In the matter of Plan Change 37 – Nukuhau

**Statement of evidence of David John Robert Smith for the Taupō
District Council (Transport)**

Dated 30th September 2021

Figure 1 Proposed Access and Network Connection (figure 5-2 from TIA)

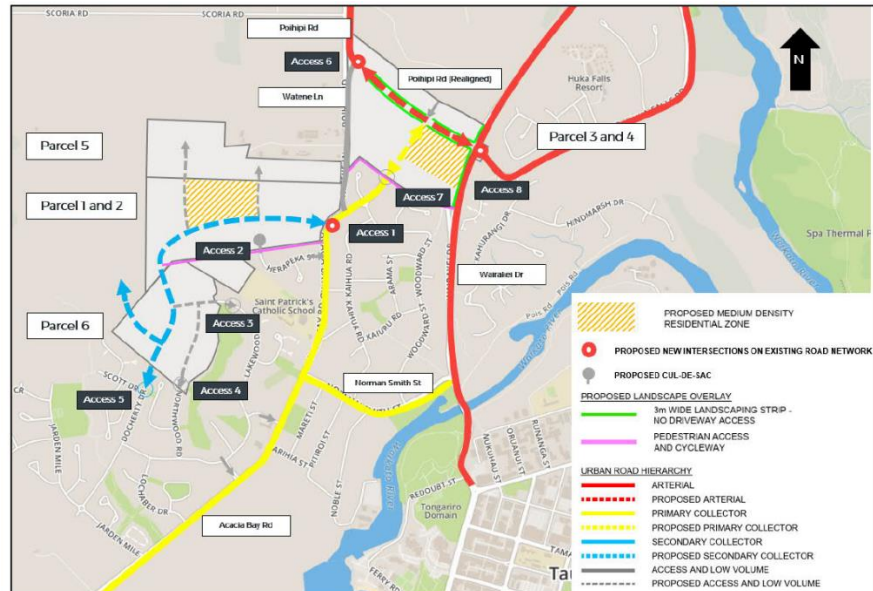
4.3 I consider the two purple shared paths are the critical new pieces of infrastructure but they do not connect the western portion of the development or to the wider cycle network shown in TDC's Cycling and Walking Strategy and shown in Figure 2 below (also included as figure 5-3 of the TIA).

4.4 I consider that an additional shared path facility is required along Acacia Bay Rd/Watene Lane on the boundary of the PC37 site, to connect the two purple shared paths from Figure 1 and I recommend that the ODP should be amended

accordingly. I have highlighted this in yellow on Figure 2 and note that this is included in an updated walking and cycling plan supplied by WSP dated 19 September 2021 and re-produced at the end of section 5 of this statement of evidence as Figure 3. I further consider that it would also be advantageous to continue cycle lanes further south along Acacia Bay Road to connect to the proposed facility (shown by dashed red lines) on Norman Smith Street but acknowledge that this is outside of the Plan Change site and that there are other local road connections that may be preferable for cycling. Accordingly, this matter is raised in terms of the Taupo District Council's wider role in terms of facilitating modal choice.

Figure 3 Cycling and Walking Routes (prepared by WSP 16/9/2021)

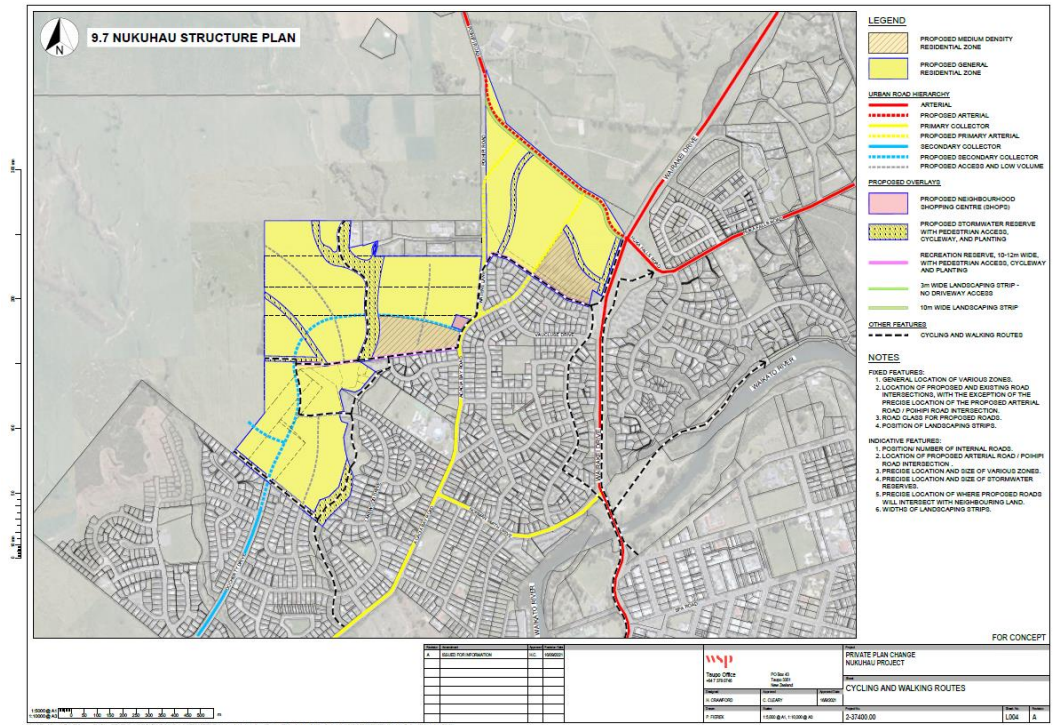
- 5.15 I further note that the Cycling and Walking Routes drawing included with the 22 September 2021 letter and traffic note includes improved walking and cycling provision including a connection along Watene Lane to connect to Acacia Bay Road as shown in Figure 3. This addition is supported and addresses my concerns raised in paragraphs 4.3-4.5.

- b providing high-quality connected infrastructure as in the updated ODP shown in Figure 3, and
 - c subsequent detailed design and safety audit processes in line with industry best practice.
